**IN THE MATTER** of an application to **SELWYN DISTRICT COUNCIL** by **CORNERSTONE ROLLESTON TRUST** to construct and operate a church at 999 Goulds Road, Rolleston (RC245009)

## **STATEMENT OF EVIDENCE OF ANDREW DAVID CARR**

- 1.12 I have been asked by the Applicant to review my earlier reviews of the proposed layout, based upon a revised layout which I received by email on 18 December 2024 (Whimbrell drawing A1.03 Rev D 'Site Car Parking Plan'). For this task, I have evaluated each of the relevant transportation rules and assessed whether the proposed layout meets the District Plan. This forms the first part of my statement of evidence.

**Figure 1: Indicative Location of Possible Pedestrian Connection to Goulds Road**

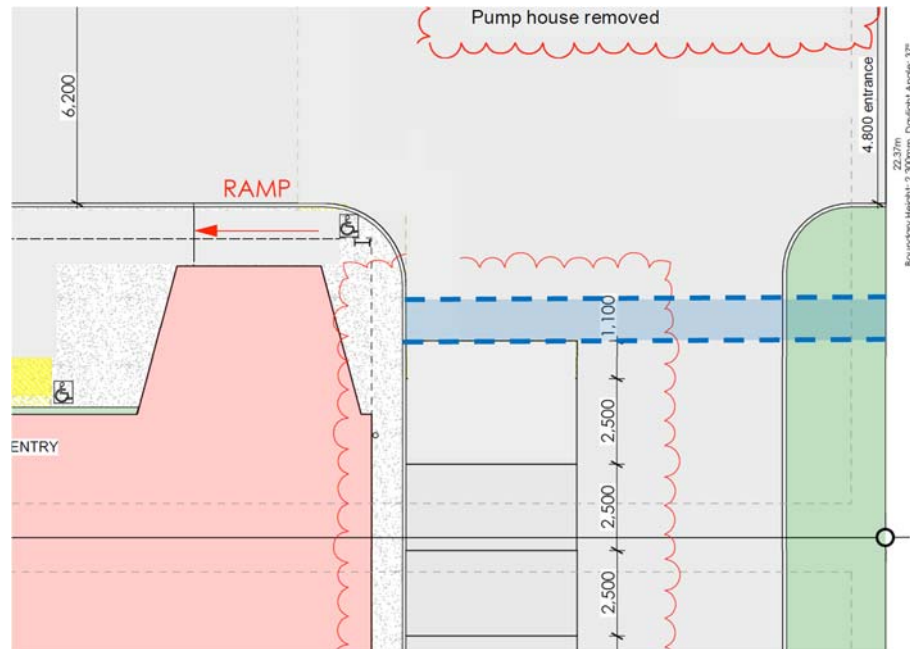
- 4.5 Matters relating to pedestrian provision are addressed in paragraphs 54 to 58 of Mr Henderson's report. Again there are no points of disagreement but I highlight that it is suggested that there should be pedestrian access provided within the site between the building entrance and Goulds Road (Henderson paragraph 54). If desired, this could be provided very easily through designating a pedestrian route running just north of Space 18, between the mobility ramp shown on the northeastern corner of the building, due eastwards to Gould Road. This would involve constructing a small amount of footpath within the proposed landscaping at the site boundary. I recommend that this forms part of the proposal.

- 4.12 Condition of Consent 26 requires a pedestrian connection between the building and Goulds Road. One option for this is shown on Figure 1 above.
- 4.13 Condition of Consent 30 requires the upgrading of Goulds Road adjacent to the site. I understand that the church is amenable to extending the footpath across the site frontage, with a cross-section that is the same as the existing footpath towards the north. However the condition of consent goes further than this, and seeks a more comprehensive upgrading.
